Modification Recommended Service Note

E5080B ENA Series Network Analyzer

Serial Numbers: MY59300001-MY59399999, SG59300001-SG59399999

Acoustic sound from PSU

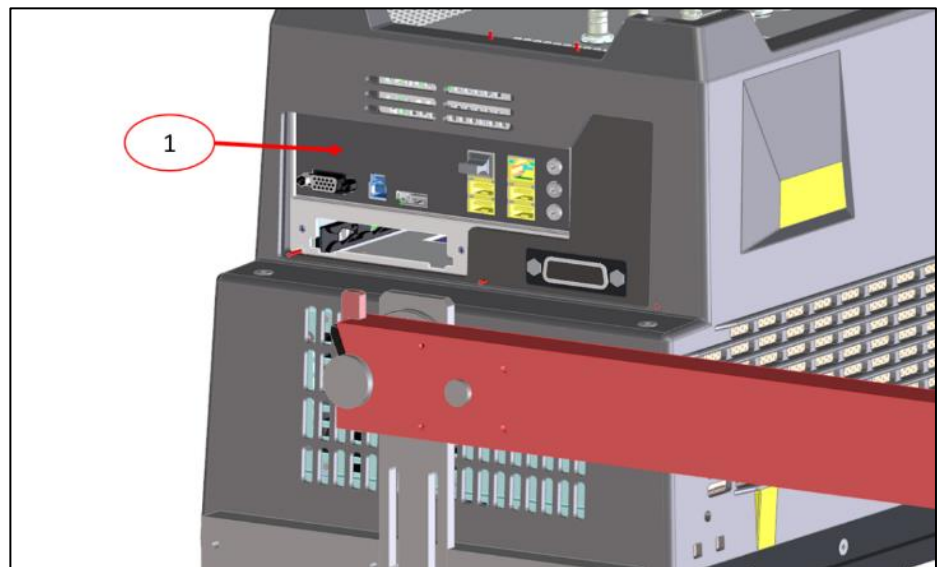
1.2 After the CPU module is installed, remember to replace the PCIO overlay as shown. The PCIO overlay cut-outs (X-Y position) for Gen2 CPU (MY593) are slightly shifted to fit Gen2 CPU and it is not 100% compatible with Gen1 CPU generation CPU. Replacement with Gen1 CPU PCIO overlay is required.

2. Power supply unit cable assembly replacement

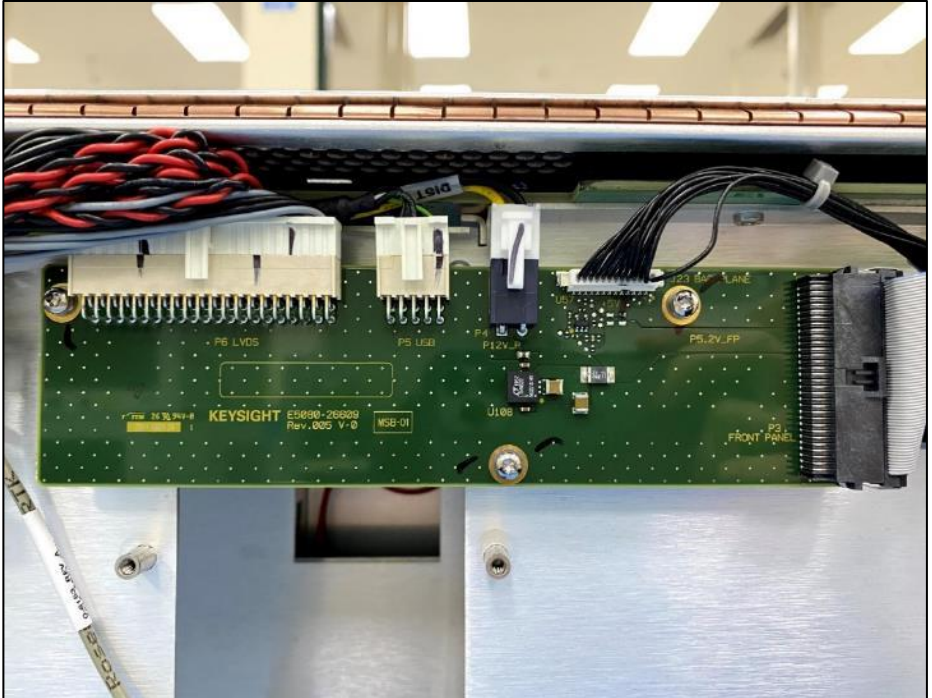
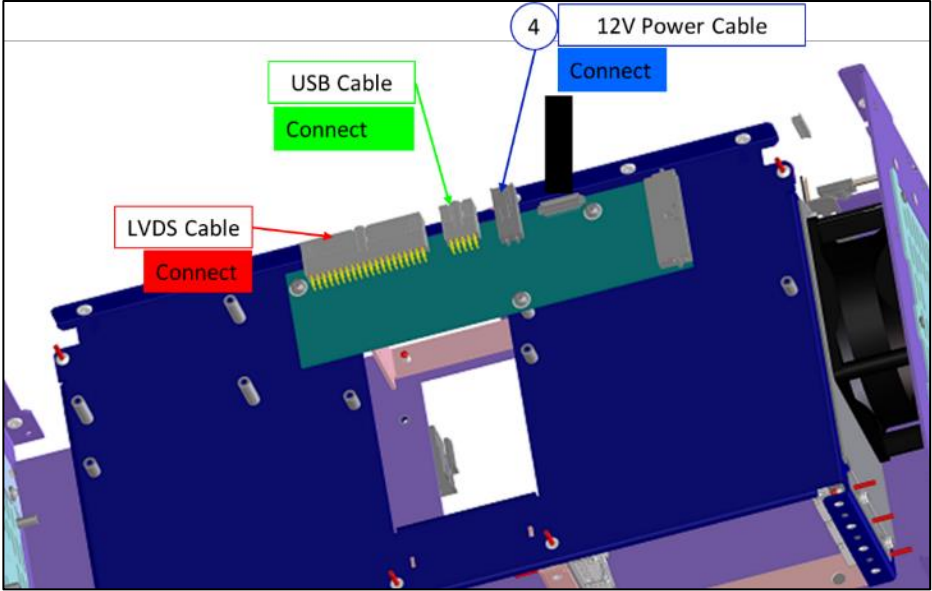
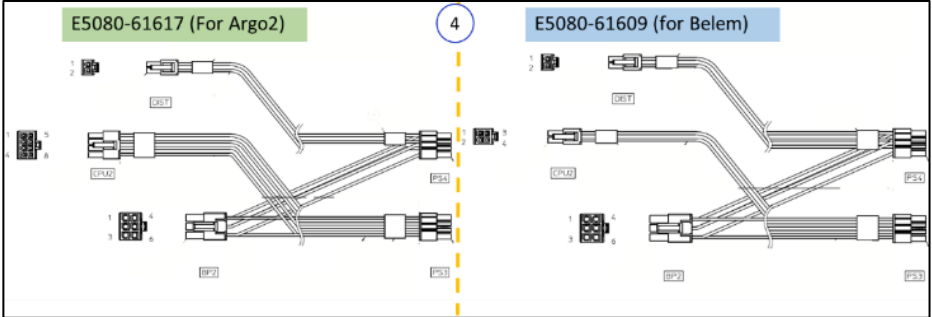
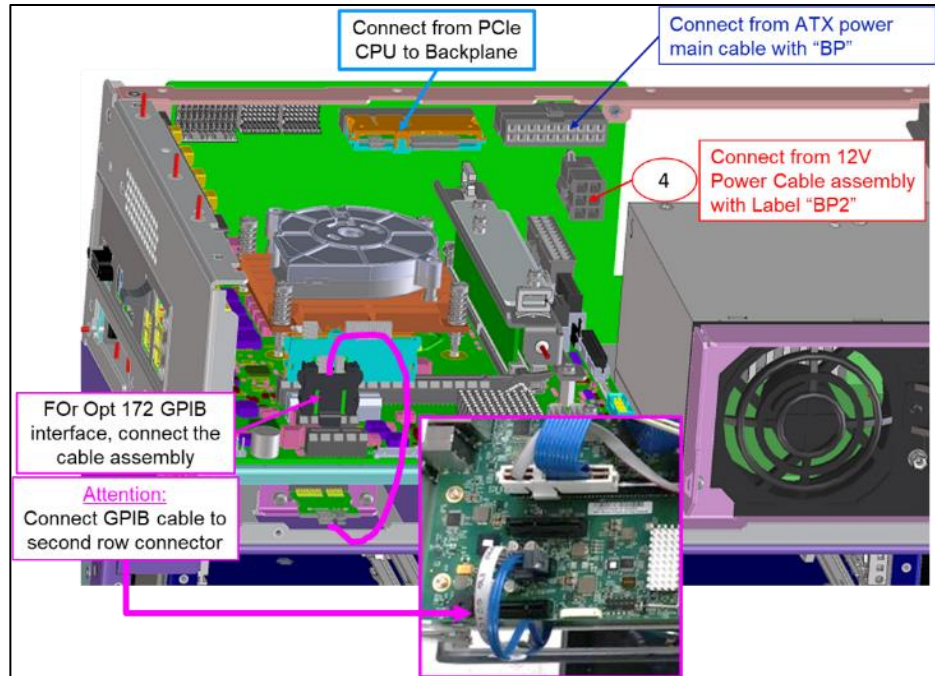
2.1 Shown is the comparison of the 12V power supply cable assembly. Perform the replacement as shown using E5080-61609.

3. Solid State Drive replacement

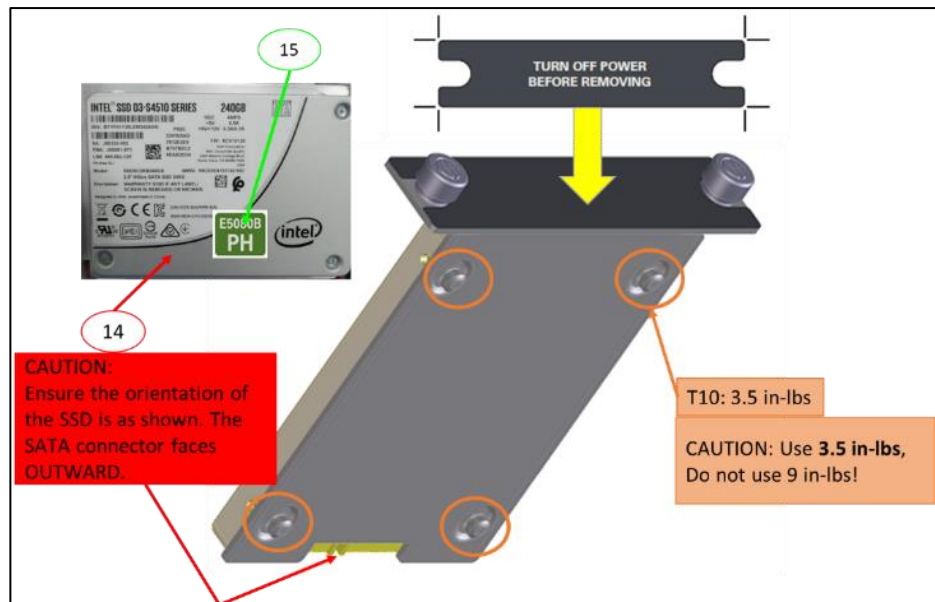
3.1 Replace the Gen2 CPU solid state drive (SSD) with SSD meant for Gen1 CPU. Reuse the removable SSD bracket and tray.
